Project	<b>IEEE 802.16 Broadband Wireless Access Working Group</b> < <a href="http://ieee802.org/16">http://ieee802.org/16</a> >
Title	<b>Amendment to EAP Security Primitives in 14.2.2.1</b>
Date Submitted	<b>2007-03-1508</b>
Source(s)	Jung-Mo Moon, Jee_Hyeon Na, Mi-Young Yun, and Sangho Lee <a href="mailto:jhna@etri.re.kr">jhna@etri.re.kr</a> ETRI 161 Gajeong-dong, Yuseong-gu Daejeon 305-700 Korea
Re:	Contribution on comments to IEEE 802.16g/D8
Abstract	Re-definition of EAP primitives in 14.2.2.1
Purpose	Adoption
Notice	This document has been prepared to assist IEEE 802.16. It is offered as a basis for discussion and is not binding on the contributing individual(s) or organization(s). The material in this document is subject to change in form and content after further study. The contributor(s) reserve(s) the right to add, amend or withdraw material contained herein.
Release	The contributor grants a free, irrevocable license to the IEEE to incorporate text contained in this contribution, and any modifications thereof, in the creation of an IEEE Standards publication; to copyright in the IEEE's name any IEEE Standards publication even though it may include portions of this contribut

Figure 473 – EAP based Authentication Procedure

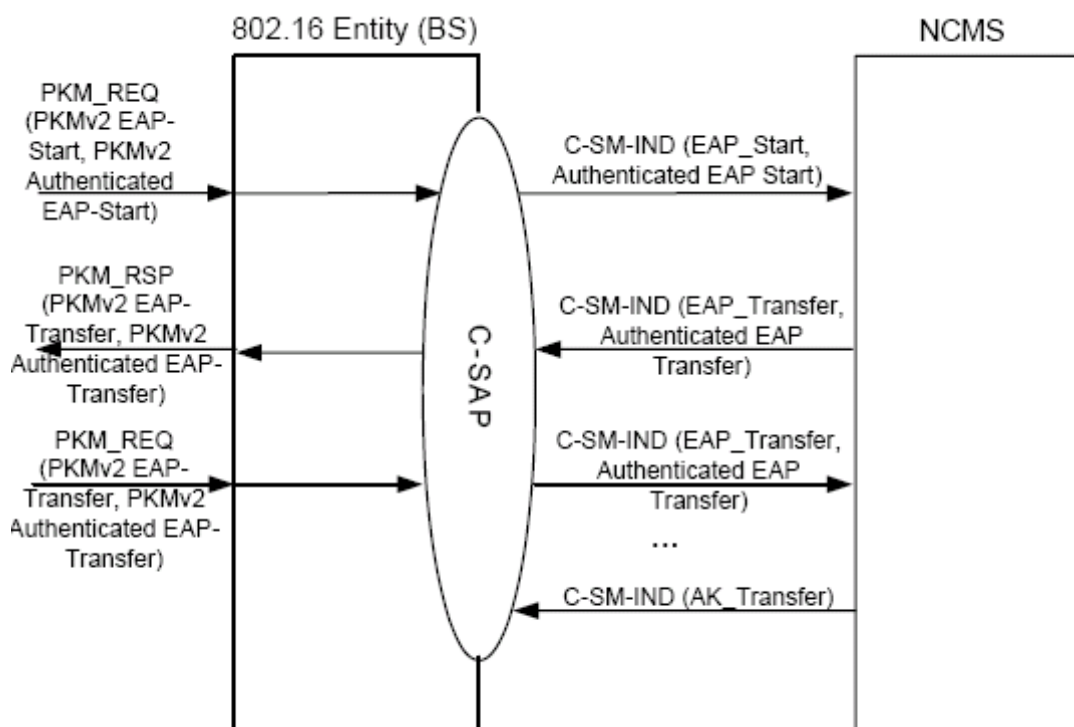
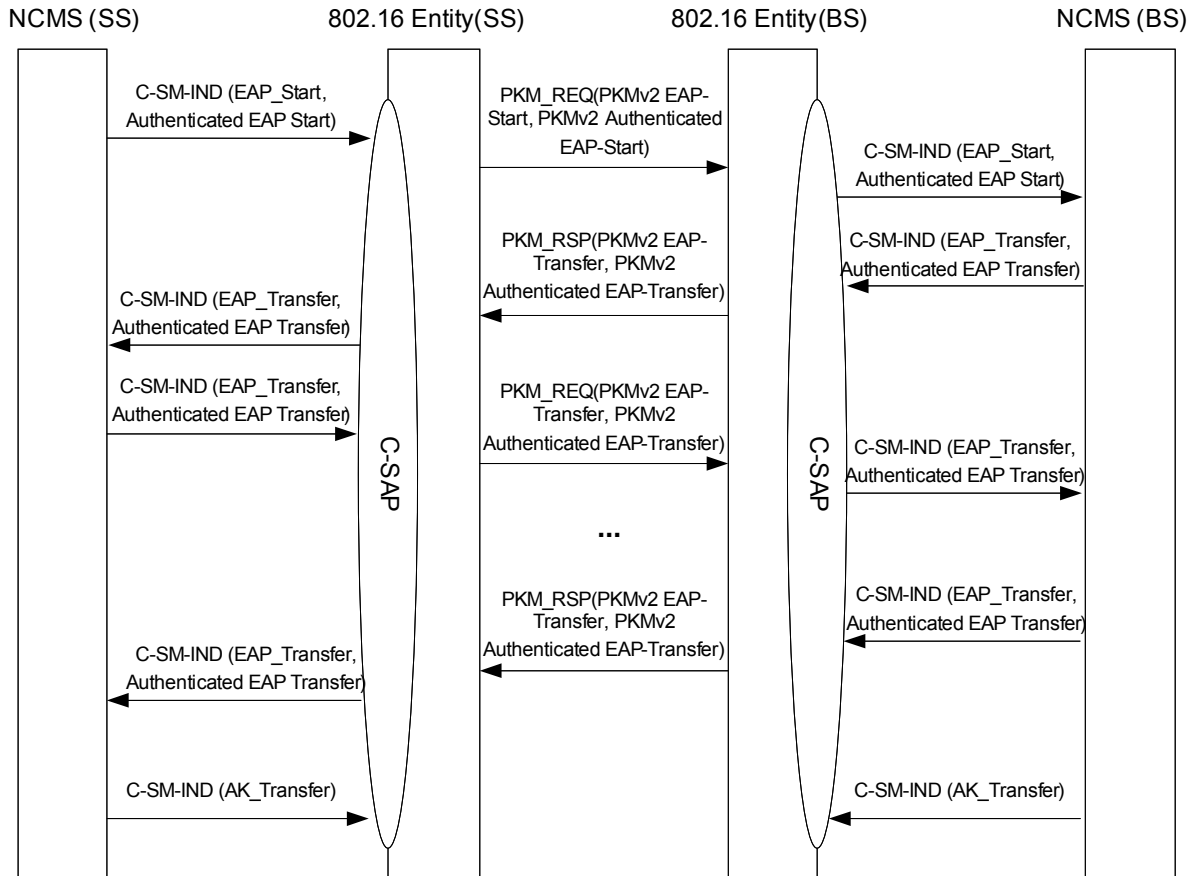
1. Modification of figure 473 to illustrate EAP-based security primitives on SS side.
2. Modification of each subsection to clarify and describe on each side (SS and BS side)

Figure 473 shows EAP-based authentication procedures between an BS-802.16 entity and an NCMS on SS and BS sides and an AAA Services entity in NCMS as follows:
